UNITED STATES PATENT AND TRADEMARK OFFICE

APPLICATION NO.	FILING DATE	FIRST NAMED INVENTOR	ATTORNEY DOCKET NO.	CONFIRMATION NO.
09/834,208	04/13/2001	G. Thomas Wolf		3950

Office Action Summary

DETAILED ACTION

Drawings

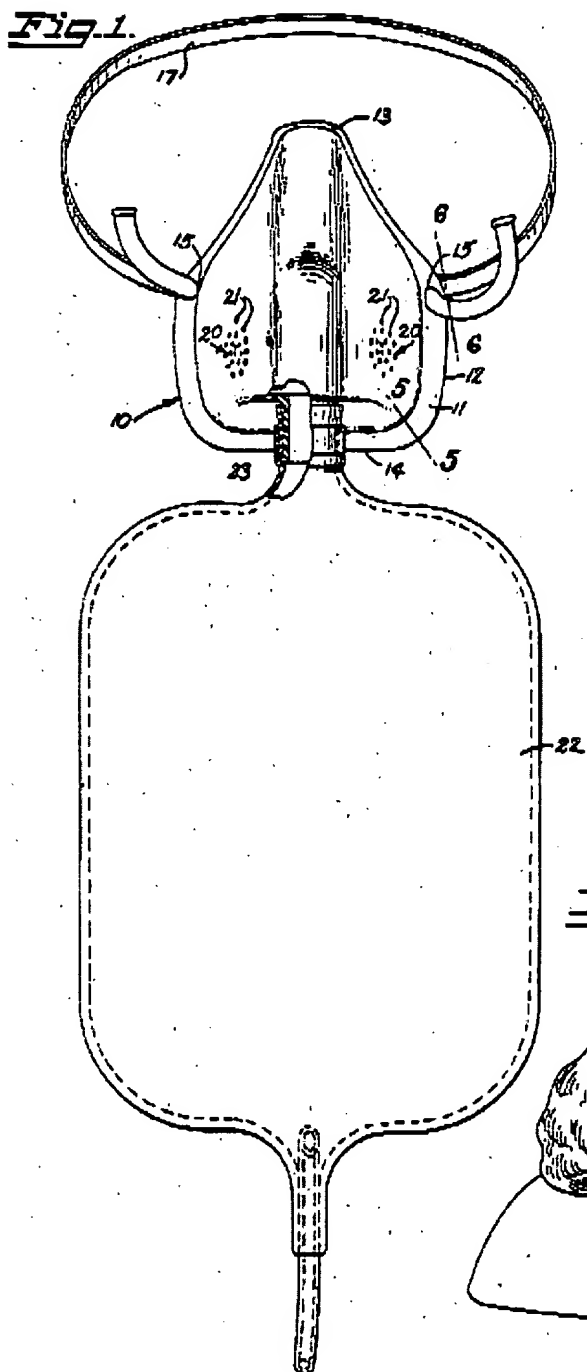
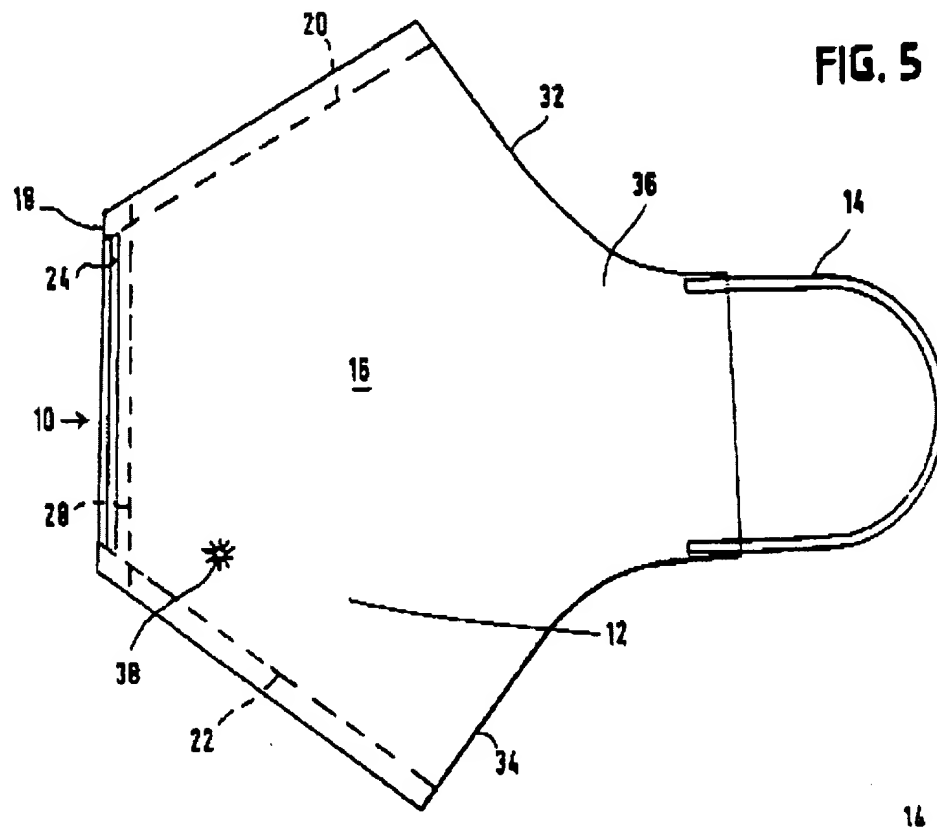
1. The drawings are objected to under 37 CFR 1.83(a). The drawings must show every feature of the invention specified in the claims. Therefore, "the second end of the strap is permanently attached" must be shown or the feature(s) canceled from the claim(s). No new matter should be entered.

Corrected drawing sheets in compliance with 37 CFR 1.121(d) are required in reply to the Office action to avoid abandonment of the application. Any amended replacement drawing sheet should include all of the figures appearing on the immediate prior version of the sheet, even if only one figure is being amended. The figure or figure number of an amended drawing should not be labeled as "amended." If a drawing figure is to be canceled, the appropriate figure must be removed from the replacement sheet, and where necessary, the remaining figures must be renumbered and appropriate changes made to the brief description of the several views of the drawings for consistency. Additional replacement sheets may be necessary to show the renumbering of the remaining figures. Each drawing sheet submitted after the filing date of an application must be labeled in the top margin as either "Replacement Sheet" or "New Sheet" pursuant to 37 CFR 1.121(d). If the changes are not accepted by the examiner, the applicant will be notified and informed of any required corrective action in the next Office action. The objection to the drawings will not be held in abeyance.
